VENICE VISION  
P.O. BOX 525  
VENICE, CALIFORNIA 90294

October 21, 2020

**Re: 2102 - 2120 S. Pacific Avenue, 116 - 302 E. North Venice Boulevard, 2106 - 2116 S. Canal Street, and 319 E. South Venice Boulevard; VTT-82288; CPC-2018-7344-GPAJ-VZCJ-HD-SP-SPP-CDP-MEL-WDI-SPR-PHP; ENV-2018-6667-SE**

BOULEVARD II (MAJOR HIGHWAY CLASS II)

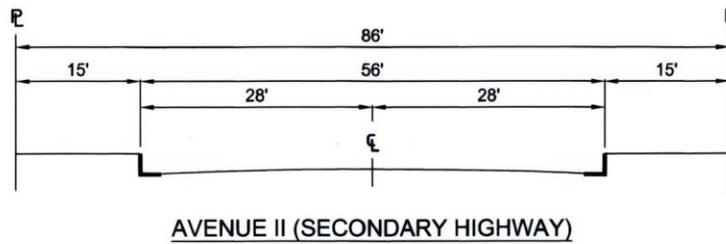
N. Venice Boulevard and S. Venice Boulevard are each classified by the City as “Boulevard II (Major Highway Class II).”<sup>125</sup> As such, each lane should measure at least 110 feet across with two lanes that are each 40 feet wide and two sidewalks—one on each side—that are each 15 feet wide.<sup>126</sup>

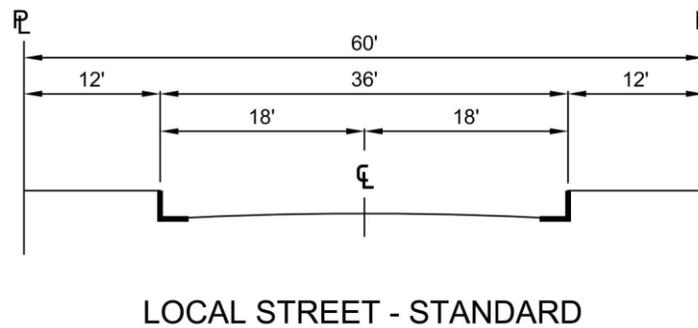
Pacific Avenue is an Avenue II.<sup>127</sup> As such, each lane should measure 28 feet across and each sidewalk should be 15-feet wide.<sup>128</sup>
